**Case #BZA25-000010**  
**Kiawah Island BZA Meeting of July 21, 2025**

**Request:** Variance request for the reduction of the required 20' side setback by approximately 93.70 square feet for a proposed guest home addition.

**BARON GUESTHOUSE**  
52 SALT CEDAR LANE  
KIAWAH ISLAND, SOUTH CAROLINA

**LOT COVERAGE - PROPOSED**

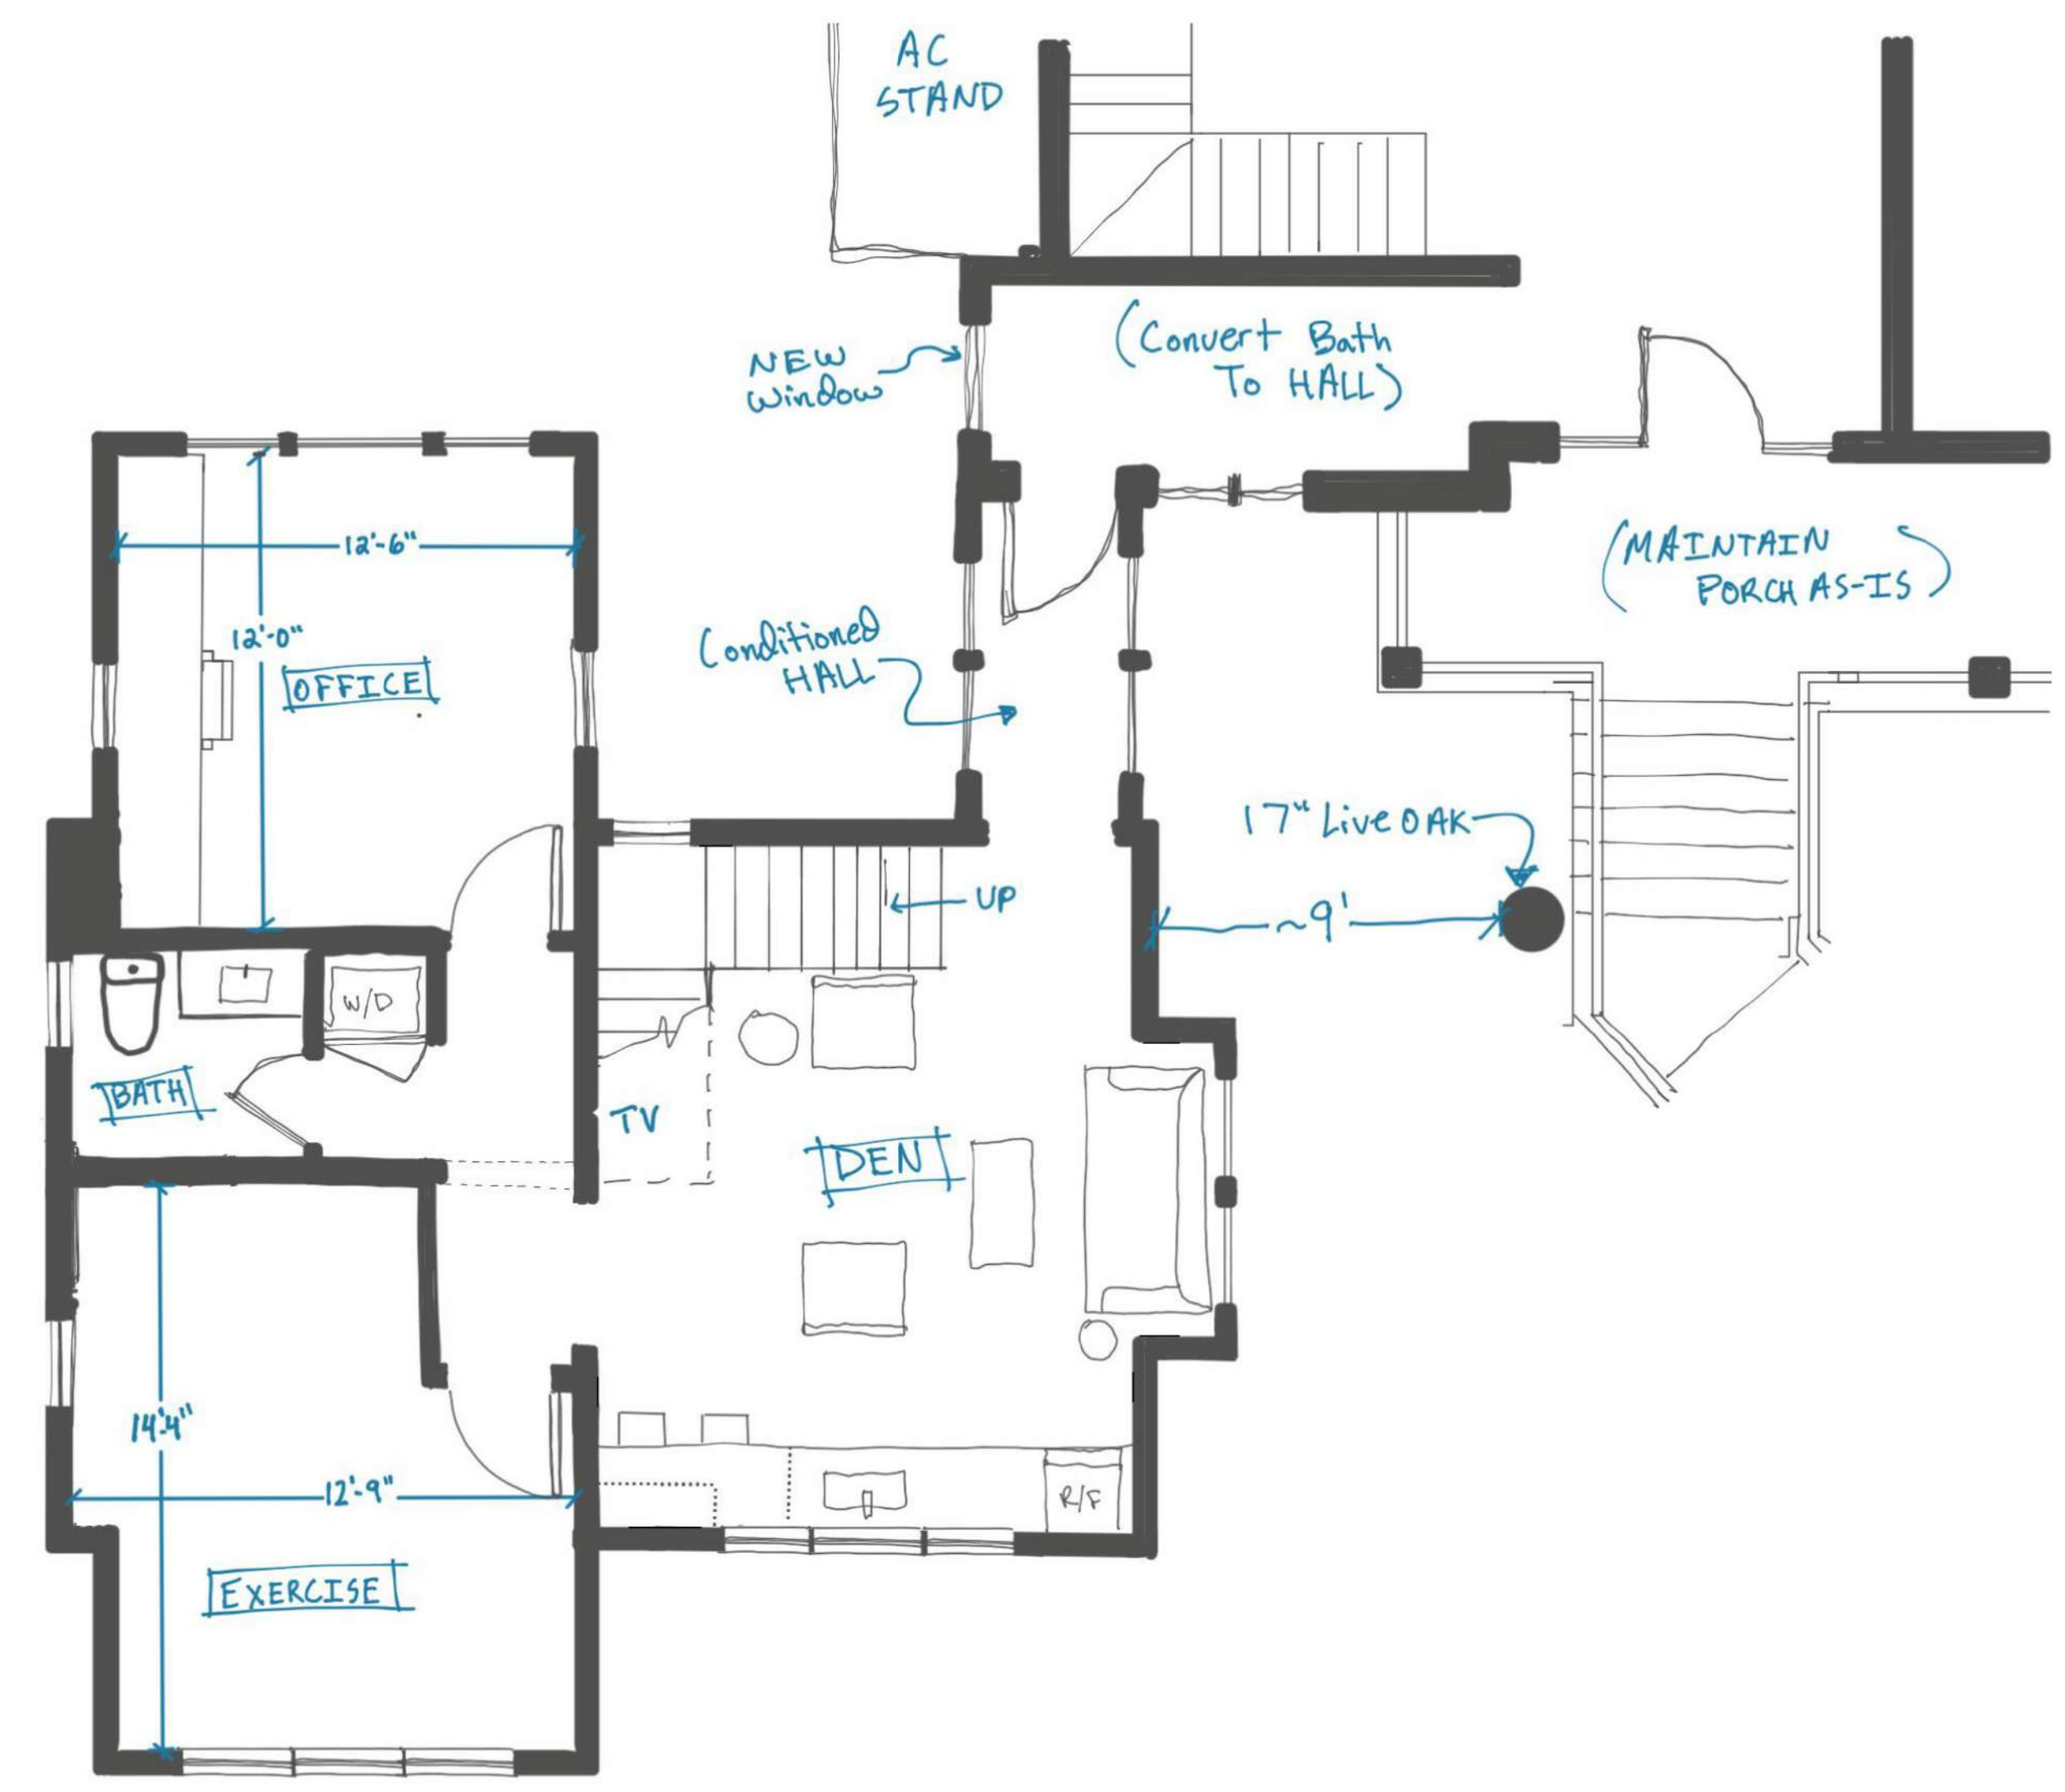
The applicant's proposed plans include construction of a guest house that encroaches 5' into the required 20' side yard setback on the west side of the subject property. The proposed guest house is located approximately 15' from the western property line at its closest point. The existing home is currently legally nonconforming with regard to setbacks. Portions of the existing home, including segments of the pool and rear screened porch, encroach into the rear setback (north) by approximately 3'. The total encroachment into the rear setback is approximately 35 square feet. The applicant is also proposing to convert a portion of the existing driveway into pervious coverage for guest parking, resulting in a 91-square-foot reduction in impervious coverage.
